LVPS Brick modifications for version 6.5.3.

B. Palan, A. Solin, A. Tikhonov
bpalan@cern.ch, tel: 162374

Date: 21 Dec 2006

Summary: This document describes the component changes on LVPS brick (3.3V, 5V, or 15V versions) from produced version 6.5 into version 6.5.3. All mentioned component names and values are referring to the scheme components designed by Ivan Hruska of version 6.5 (or 6.4 as seen in this document on page 4). Previously published brick version 6.5.2 (28 Nov 2006) follows the same changes except that discussed points No.10 (Switching frequency back to 300kHz and high L4 inductors for weakly loaded bricks), No.14 (Additional 200V independent divider), No.15 (Feedback phase margin improvements for all bricks), No.19 (Preloads for all 15V bricks) and No.20 (Preload for 5VHV) are different. Complementary document to this paper, "BrickReconstForTech_v6.5.3.pdf", is recommended to read for more detailed information.

REV. 8.4	DATE: 23.03.04	ENG: MANHARSKA
PROJECT: LV ISOLATED BRICK FOR LEGAL		
COMPANY: GERNI		
ADDRESS: GERNI SEIBERLE		
CITY: GERNI		
COUNTRY: SWITZERLAND		
INITIAL	23.03.02	PAGE: 1 OF: 1

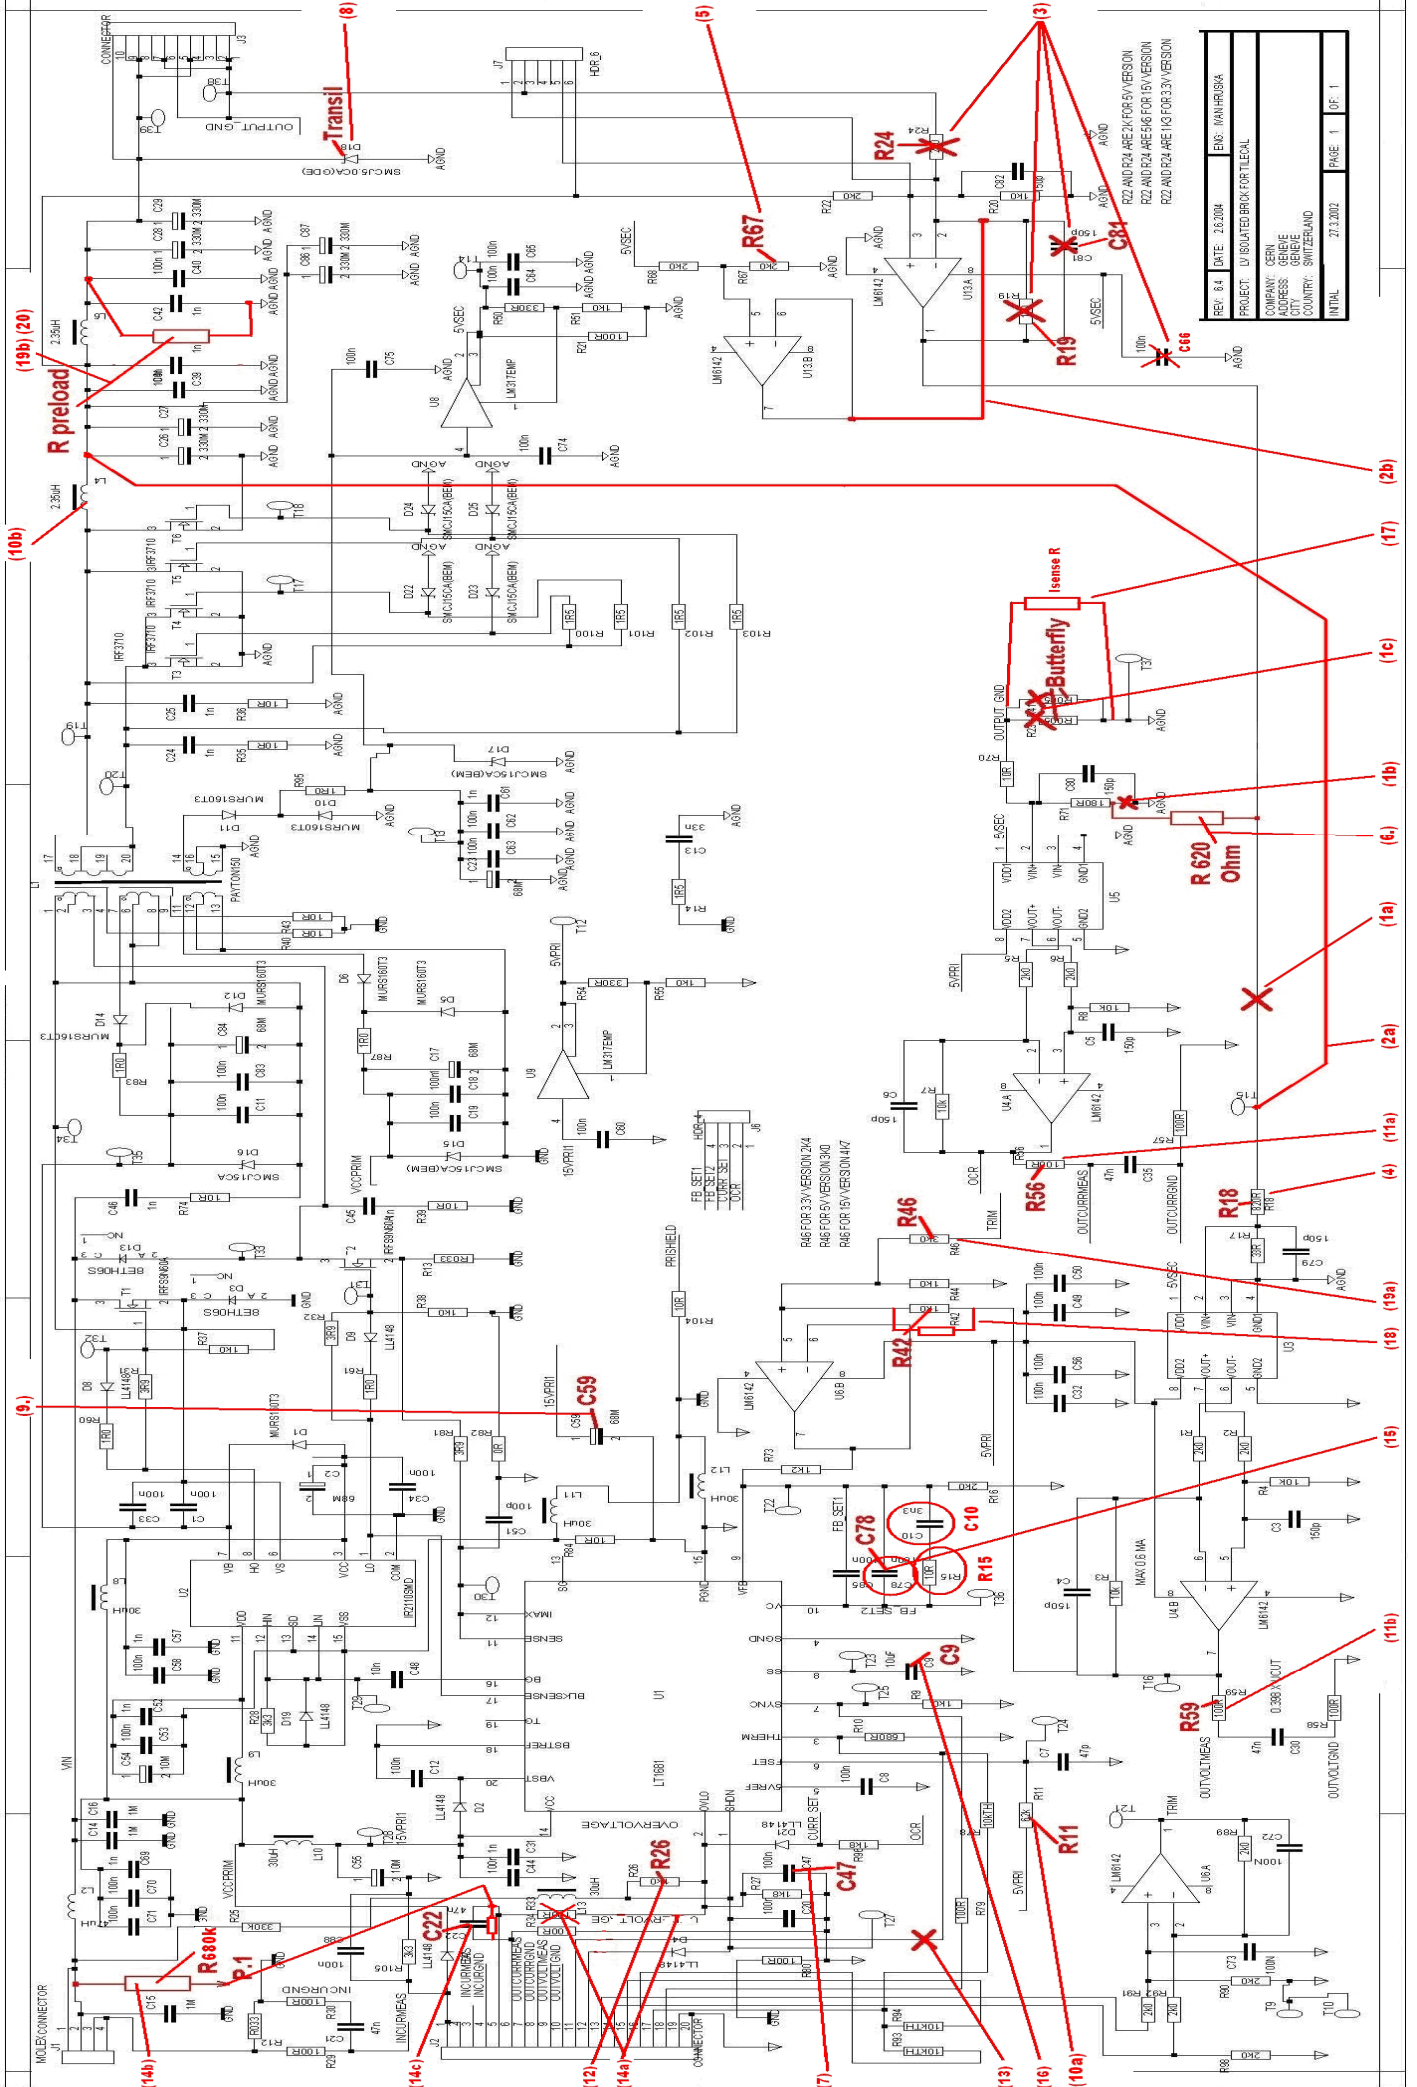
1. Cut PCB wires:

- (a) between T15 and pin 1 of U13
- (b) between GND pins R71 and C80
- (c) "Butterfly" Isense pcb traced resistors on top side and bottom side.

2. Provide two wired short cuts:

- (a) Connect the Divider R17, R18 to the output filter (30 mm piece of wire with isolation).
- (b) Provide reference between pins 7, 6 and 2 of the U13 for the comparator.

3. Unsolder components R19, R24, C81 and C66.

4. Change the value of the resistor R18 by Table 1:

5. Change the value of the resistor R67 by Table 2:

6. Solder one 620 ohm resistor between U13 (pin 1) and R71 (to provide comparator function through the current feedback).

7. Unsolder C47 (to speedup the OVP reaction.)

8. Remove TRANSIL from output of the Brick.

9. Unsolder and remove C59.

10. Switching frequency back to 300kHz and high L4 inductors for weakly loaded bricks.

- (a) Resistor R11 will be as in original version v6.5, **R11= 62kOhm**. Its value together with capacitor **C7=47pF** should be kept original too.
- (b) L4 inductors of DC/DC converter have to be added for weakly loaded bricks in order to ensure continuous current mode of DC/DC controller. All 3x15V and 5VHV brick will change, see following Table3:

11. Changing the value of the resistors R56 from 100Ohm to 10kOhm (**11a**), R59 from 100Ohm to 10kOhm (**11b**) (Protects feedback gain from influence of ELMB power cycle.)

12. Unsoldering R26 = 1kOhm (under voltage = 190V). Soldering R26 = 1.5kOhm (under voltage limit = 135V).
13. Cut trace from pin 11 of J2 connector. This disconnects the ELMB from LT chip's Thermal Shutdown if pin 3, and removes one brick Temperature measurement. The brick Thermal shutdown will still function.

14. **Additional 200V independent divider:** Unsolder R33 resistor on bottom pcb side (**14a**). Then connect its one empty end after this resistor (that is going to pin 5 of J2 connector) with 680kohm wire resistor (0.25W, 1%) on +200VDC (**14b**) pins of J1 connector on bottom side. Unsolder C22 capacitor and on its place put resistor R = 3.6kOhm (**14c**). This gives an additional 200V divider for Vin measurement that is not influenced by LT current consumption.

15. **Feedback phase margin improvements.** It has been measured and justified to have the same feedback network components for all bricks. The original C78 capacitor of 100nF (as well as 10nF proposed in brick version v6.5.2) was found acceptable for highly loaded bricks and steady state Iout current conditions, unfortunately, it is very inadequate for Iout transient requirements and for weakly loaded bricks with high L4 inductors. In order to have phase margin at minimum of 45degrees ad more, the feedback components between pins 9 and 10 of LT controller has to be added: **Capacitor C78 = 33nF, add missing R15 = 3k3, add missing C10=200nF.**

16. **Start-up Sequence.** To start the bricks in sequence in one LVBOX it is necessary to change C9 by table 3. Here you find a comparison between C9 values of the original version v6.5 with identical capacitors (all bricks started at the same time), modified version v6.5.1 from 19th of Oct 2006 with already proposed start-up sequence, and proposed C9 values for final version of brick v6.5.2/ v6.5.3.

17. Maximum Iout current limit of bricks. First cut one end of both Isense-resistors R23 and R41 (“Butterfly” pcb Isense resistors) (1c) and solder new values by the following table 4, SMD size 2512. Over current protection limits (OCP) at Vout of each brick are listed.

18. Adjust feedback gain: Table 6.

- Brick starts at minimum trimming: measure Vout
- By formulas in Excel calculate additive (parallel) resistor for R42 (SMD size 0603):
- $R_n = 2 * (V_{theor} / V_{out}) - 1$;
- $R_{add} = R_n / (1 - R_n)$;
- Take nearest nominal in row E24(1%), size 0603, soldered in parallel with R42.

19. Additional modifications for all 15V bricks:

- (a) Replace R46: from 4.7k to 7.5k (to reduce trimming range)
- (b) Preload resistors are connected directly on Vout connector between positive and return pins. All resistors have the same value of 47Ohm, power resistor in TO220 package, rated for 20Watts, see following Table 7.

20. Additional modifications for 5VHV brick:

Put preload resistor of 47Ohm. Preload resistors are connected directly on Vout connector between positive and return pins.

Brick type	R18(new value)
3.3V	1.1k
5.0V	1.8k
15.0V	5.1k

Brick type	R67(new value)
3.3V	1.1k
5.0V	1.3k
15.0V	1.8k

Brick	L4 [uH]
3VDIG	stay same
5VDIG	stay same
5VMB	stay same
-5VMB	stay same
5VHV	47
15VHV	150
15VMB	150
-15VHV	150

Brick's type	V6.5.orig.	v.6.5.1 19 Oct2006		v.6.5.2-3 08 Nov 2006	
	C9	C9	Start seq.	C9	Starts seq.
-5V MB	10uF	1.2uF	1.	1.0uF	1. first
+15V MB	10uF	25uF	3.	4.7uF	2. second
+5V MB	10uF	10uF	2.	* 10uF	3. third
+3.3V DIG	10uF	1.2uF	1.	4.7uF	2. second
+5V DIG	10uF	10uF	2.	* 10uF	3. third
-15V HV	10uF	1.2uF	1.	1.0uF	1. first
+15V HV	10uF	10uF	2.	4.7uF	2. second
+5V HV	10uF	25uF	3.	* 10uF	3. third

Brick type	V6.5	v.6.5.1	19 Oct 2006	v.6.5.2-3	08 Nov 2006
	OCP [A]	Isense resistor	OCP [A]	Isense resistor	OCP [A]
-5V MB	16-20	2x5mOhm	16	3mOhm	13
+15V MB	16-20	5mOhm	8	22mOhm	2
+5V MB	16-20	1.5mOhm	20	2mOhm	18
+3.3V DIG	16-20	2x5mOhm	16	3mOhm	13
+5V DIG	16-20	2x5mOhm	16	3mOhm	13
-15V HV	16-20	5mOhm	8	10mOhm	4.5
+15V HV	16-20	5mOhm	8	22mOhm	2
+5V HV	16-20	5mOhm	8	22mOhm	2

Type of Brick	Vmin [V]	Vmax [V]	OVP [V]
3V	3.25±50mV	3.9±50mV	4.2±100mV
5V	5.0±50mV	5.9±50mV	6.1±50mV
15V	14.4±100mV	15.65±100mV	16.0±100mV

Brick	Iout range [A]	Preload [Ohm]
3VDIG	1.7 - 5.6	No
5VDIG	3.3 - 6.7	No
5VMB	6.6 - 13.3	No
-5VMB	3.3 - 6.7	No
5VHV	0.1 - 0.3	47
15VHV	0.15 - 0.4	47
15VMB	0.2 - 0.6	47
-15VHV	0.15 - 1.9	47
